City of Portland, Maine - Building or Use Permit Application

Permit No: 01-0372	Issue Date: APR 25 2001	CEL: 090 G005001
-----------------------	----------------------------	---------------------

Proposed Project Description:
Build 30'9" x 8' covered porch & interior renovations.

BUILDING PERMIT REPORT

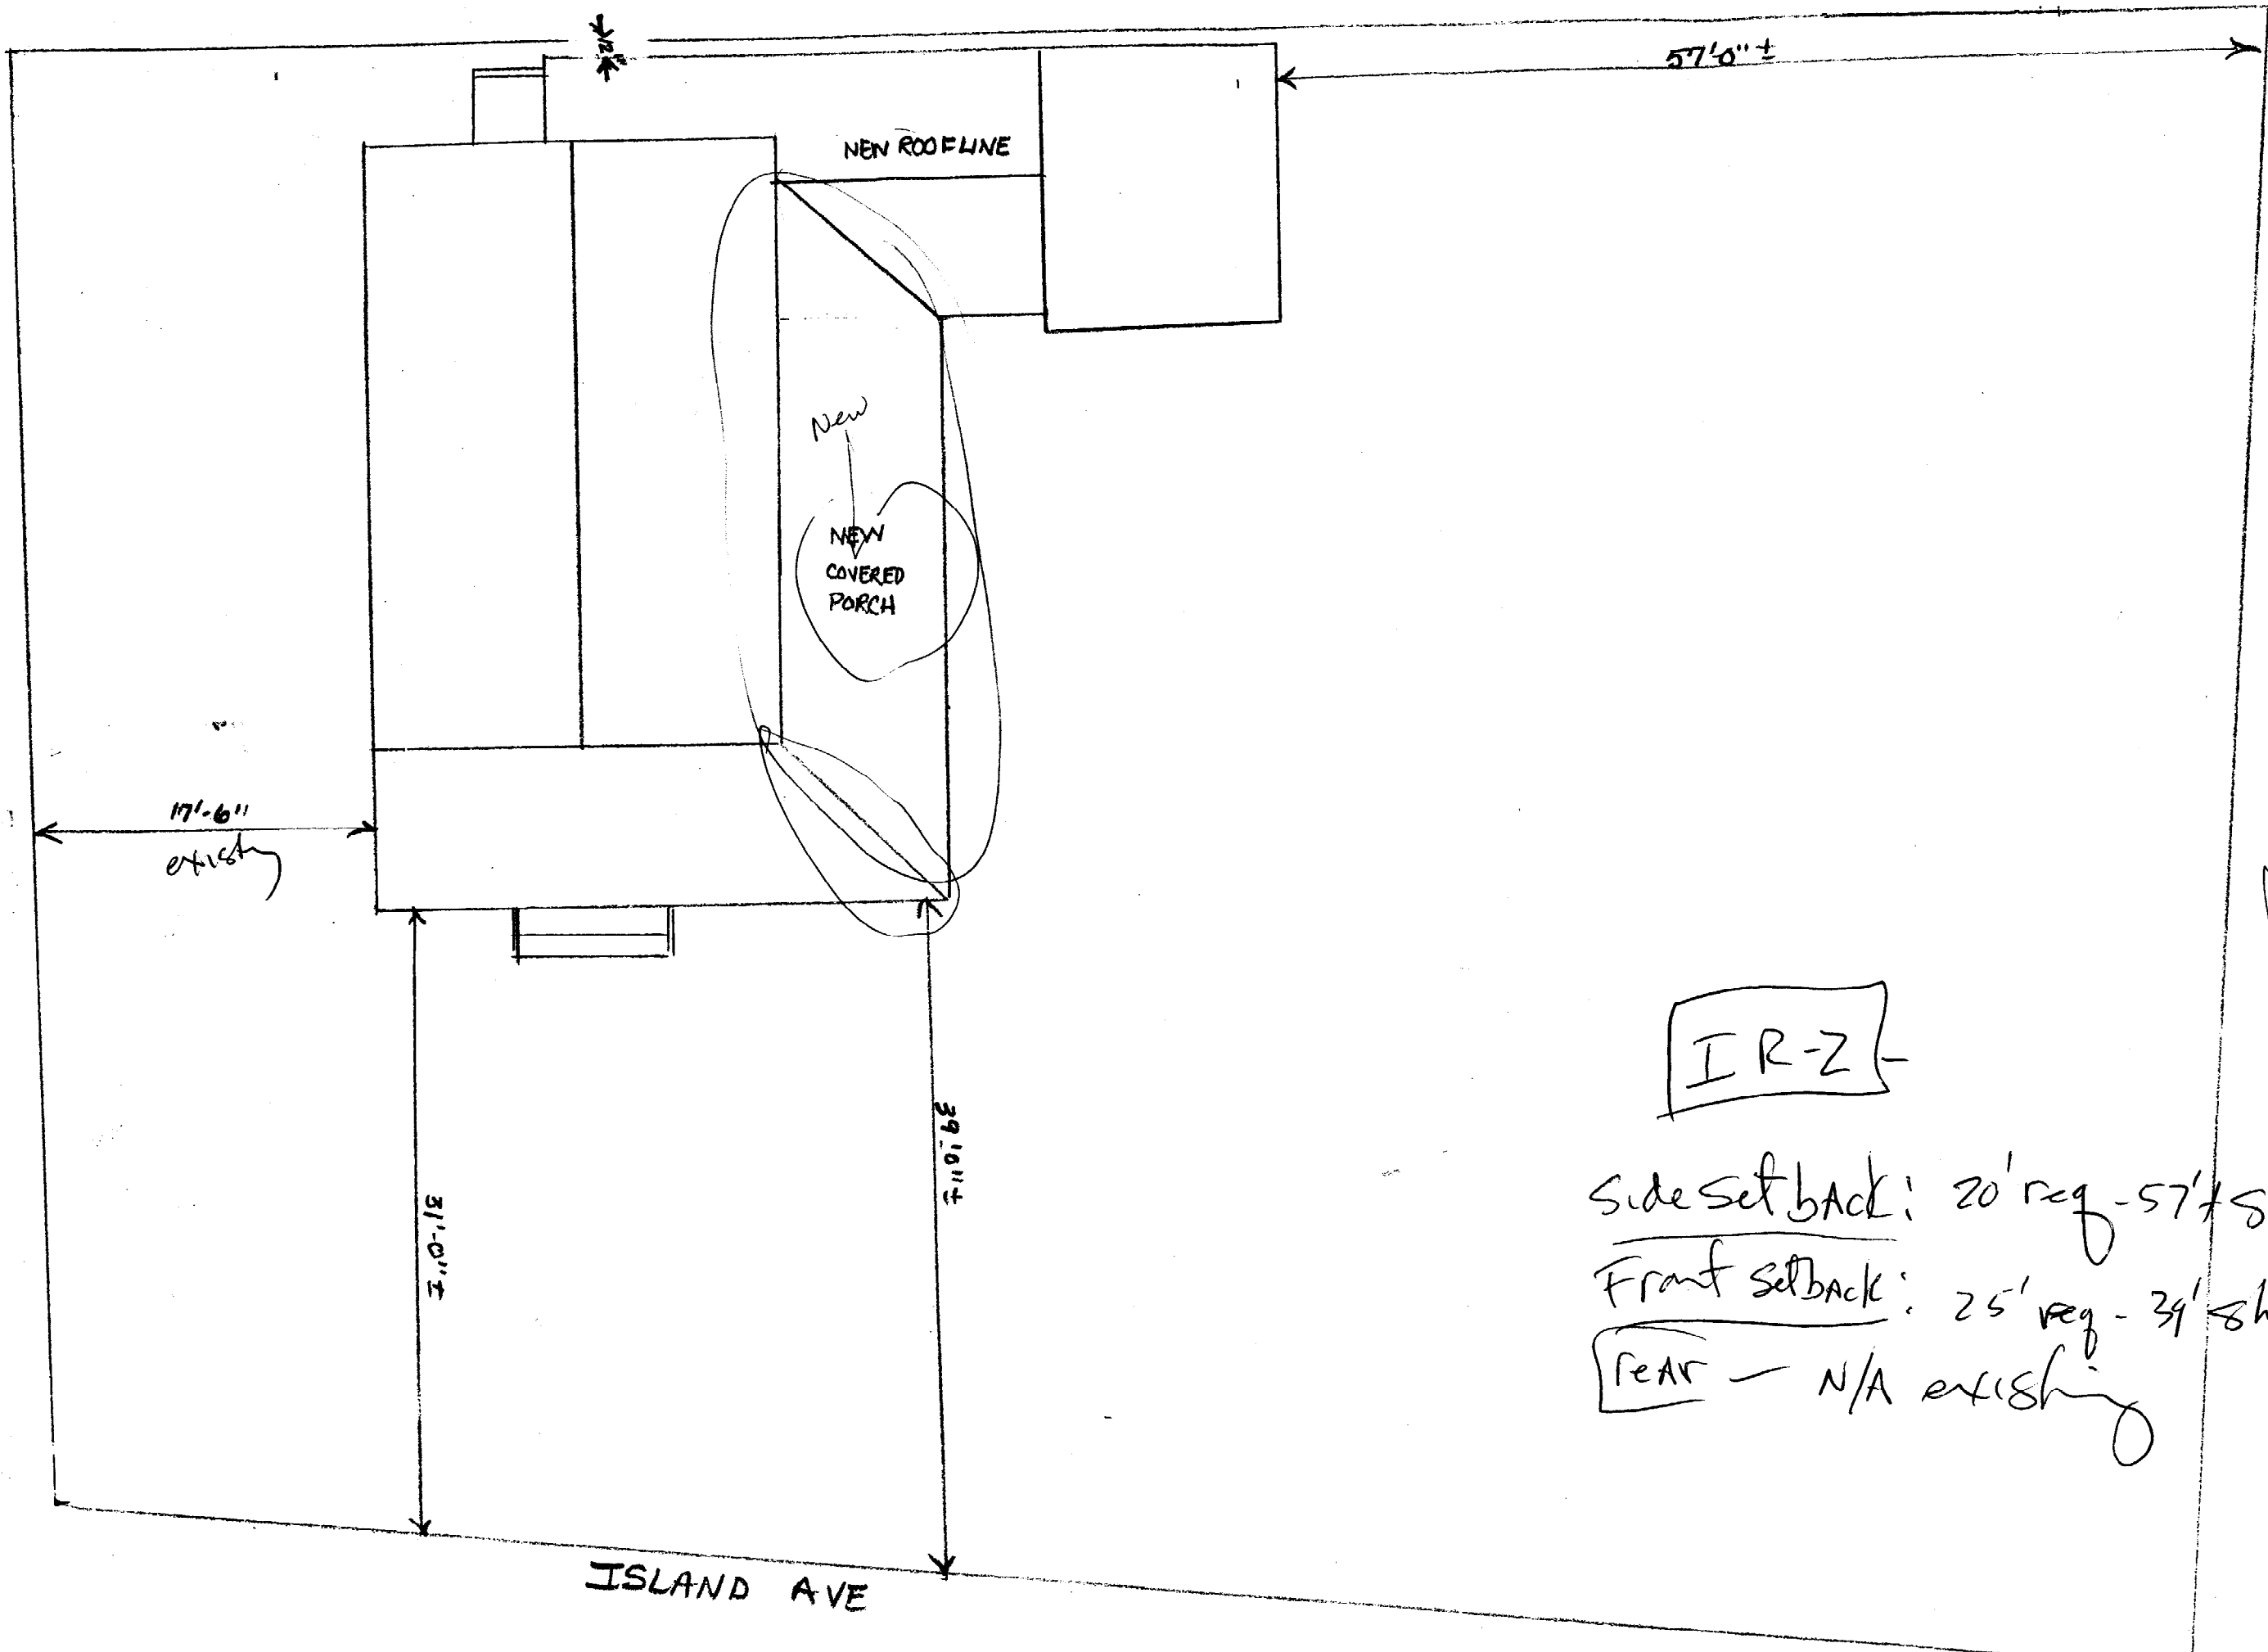
Side setback: 20' req - 57' show

Front setback: 25' req - 39' show

Rear - N/A existing

Margie
Watch This
Looks like 2

JILL KEEFE REM
448 ISLAND AV
ISLAND

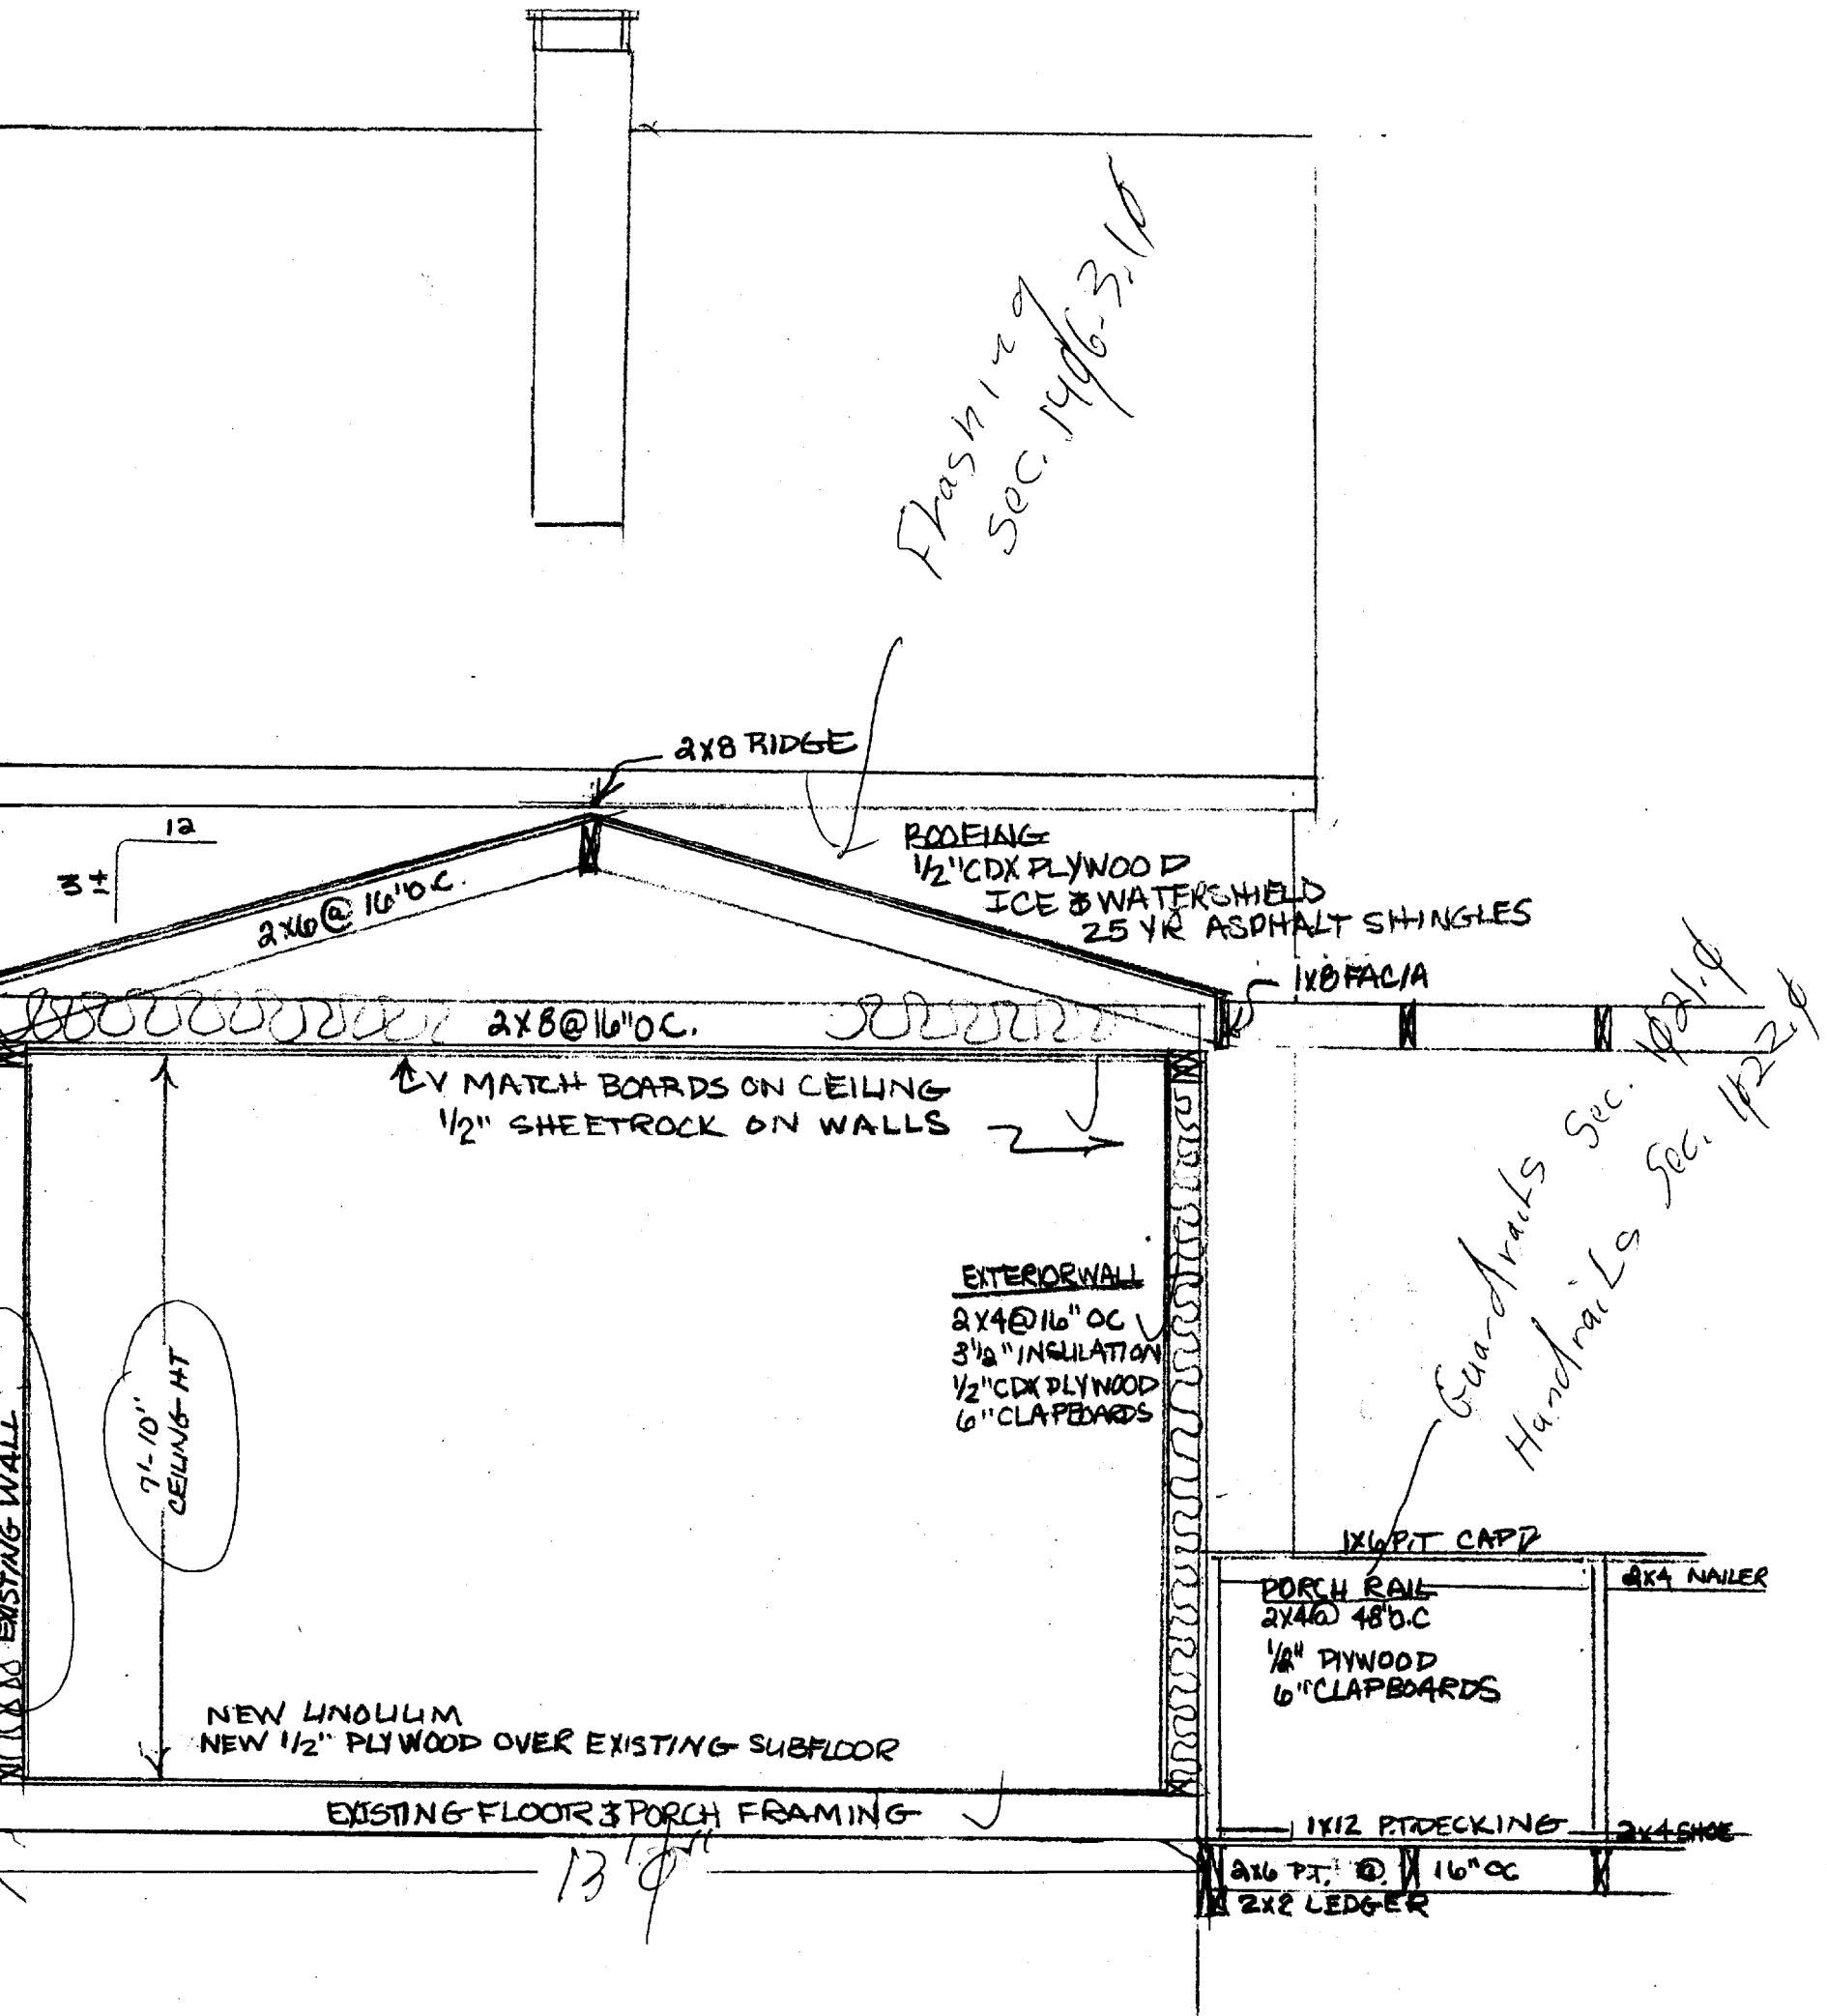
Flashing 7
SEC. 1406.3.

JILL KEEFE REMODEL
448 ISLAND AVE

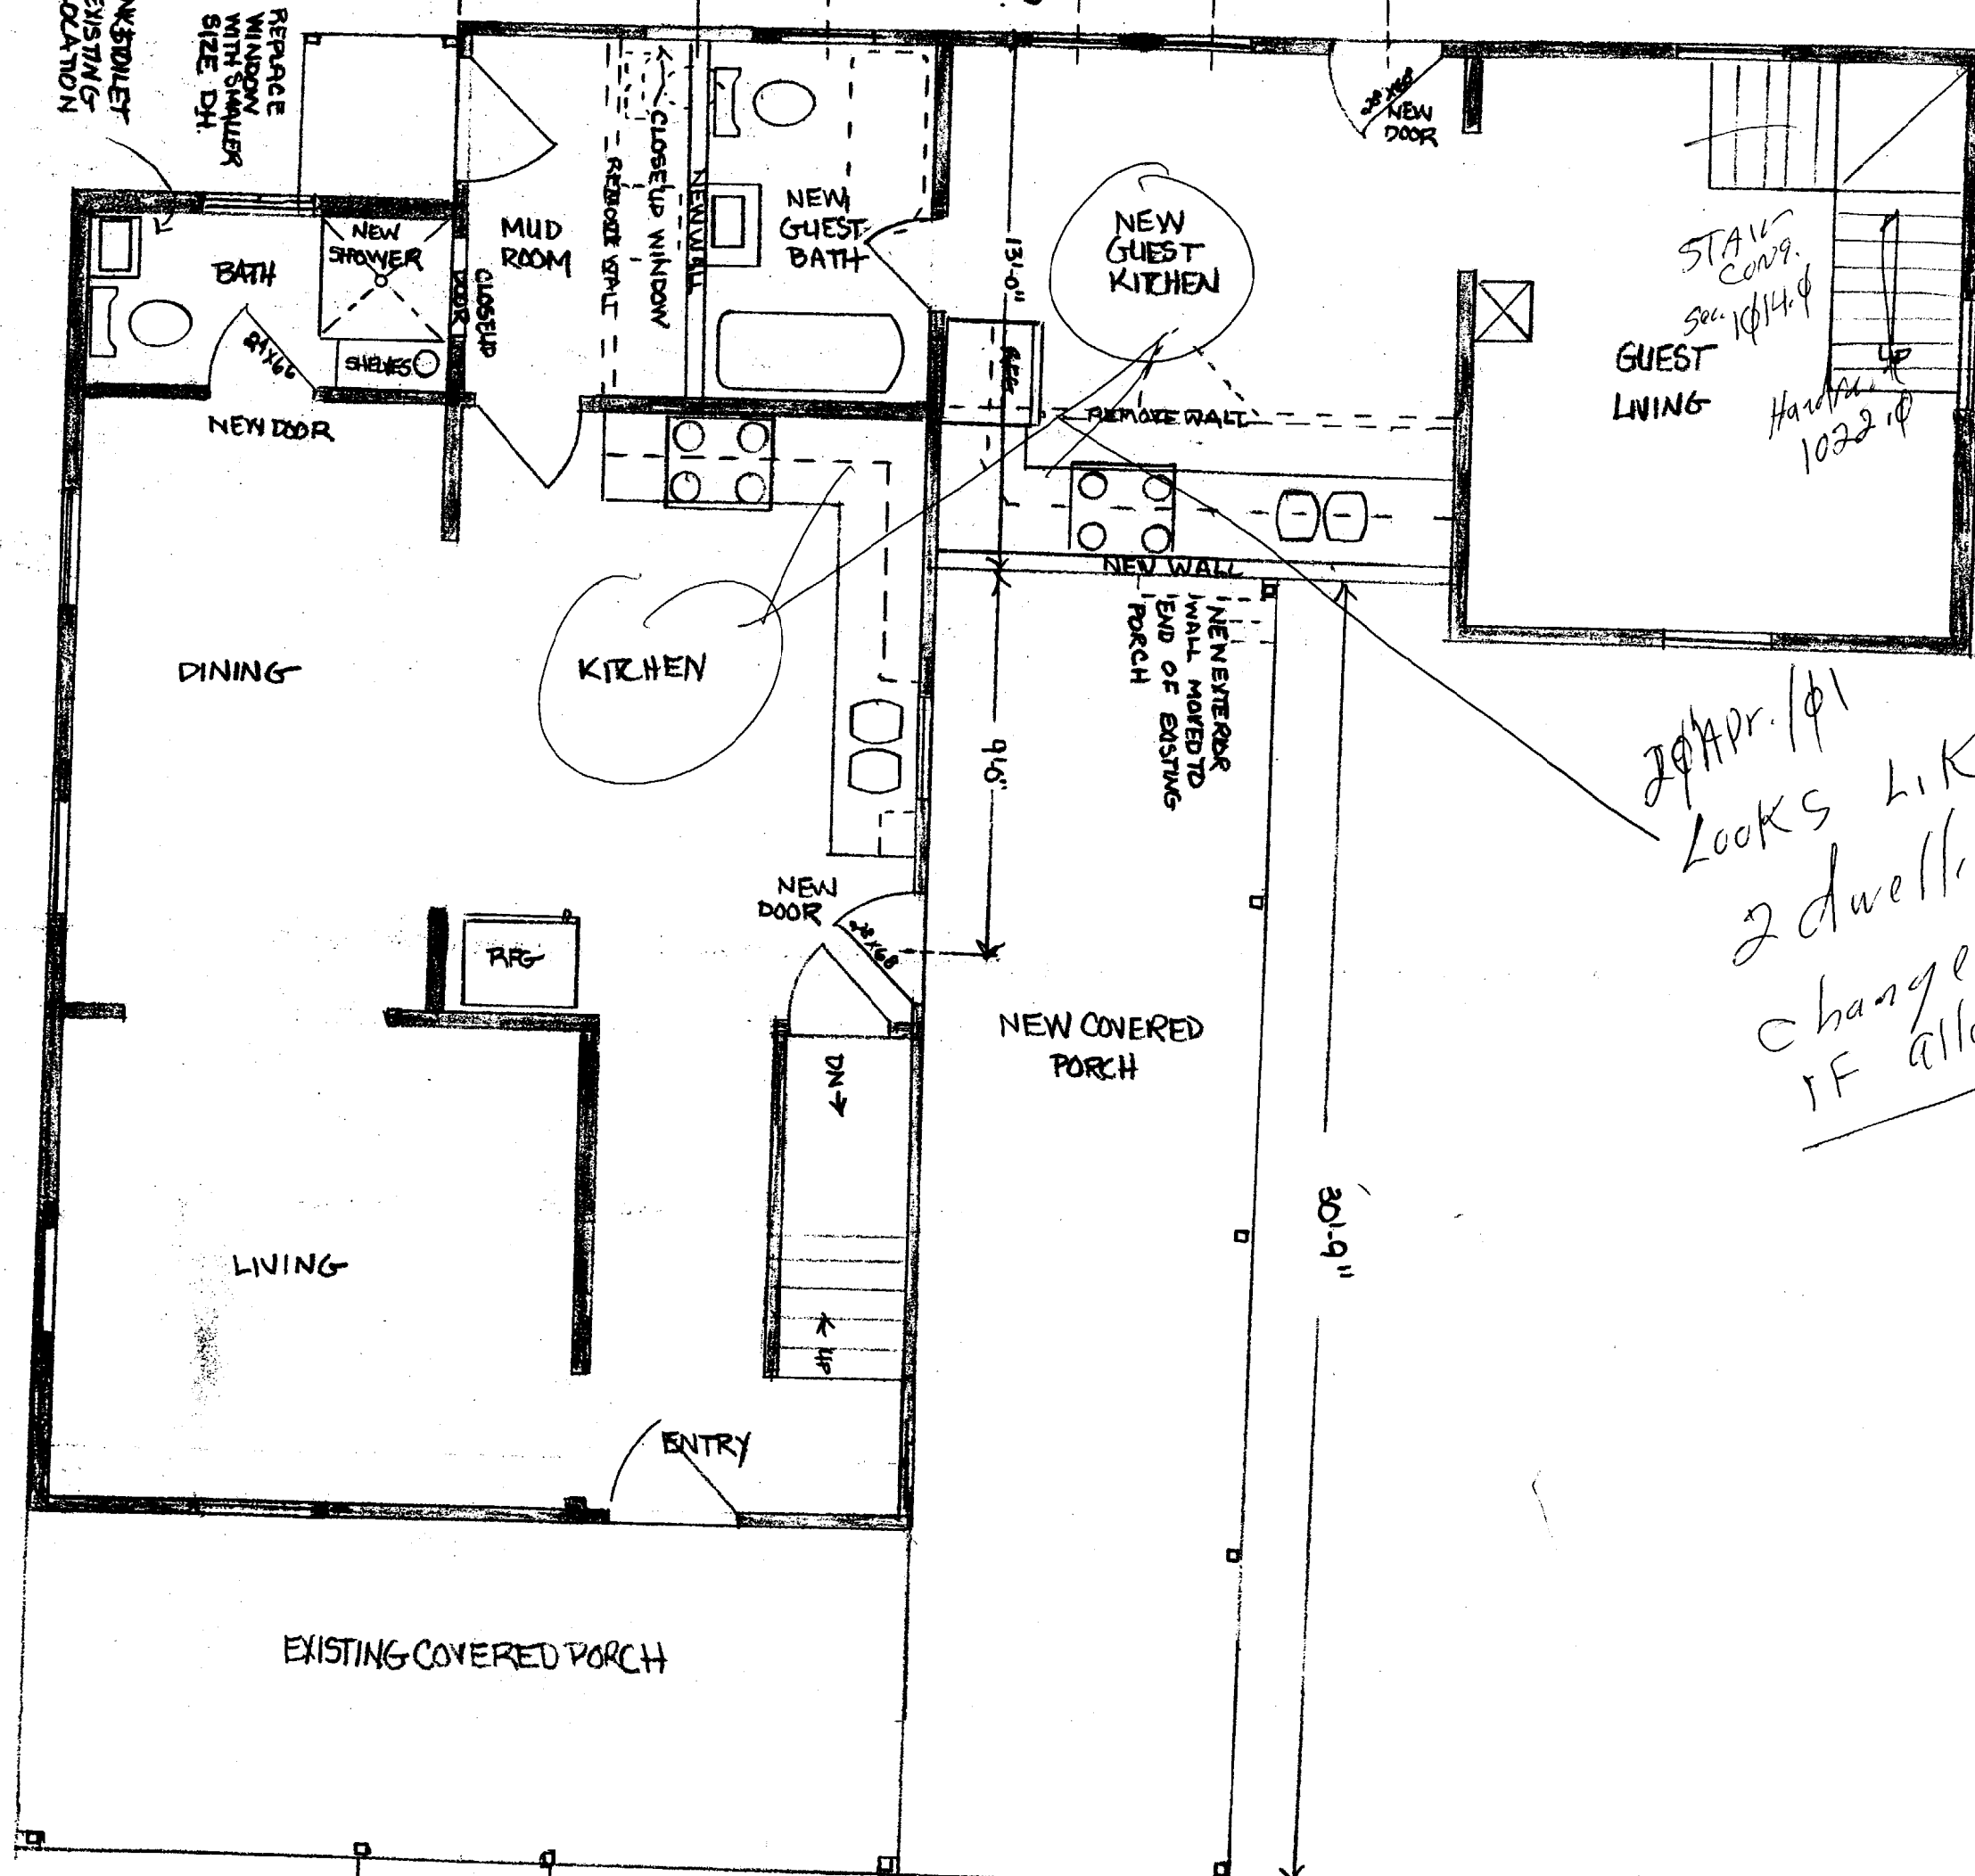
2/4/01
 Looks like
 2 dwelling units?
 change of use?
 IF allowed
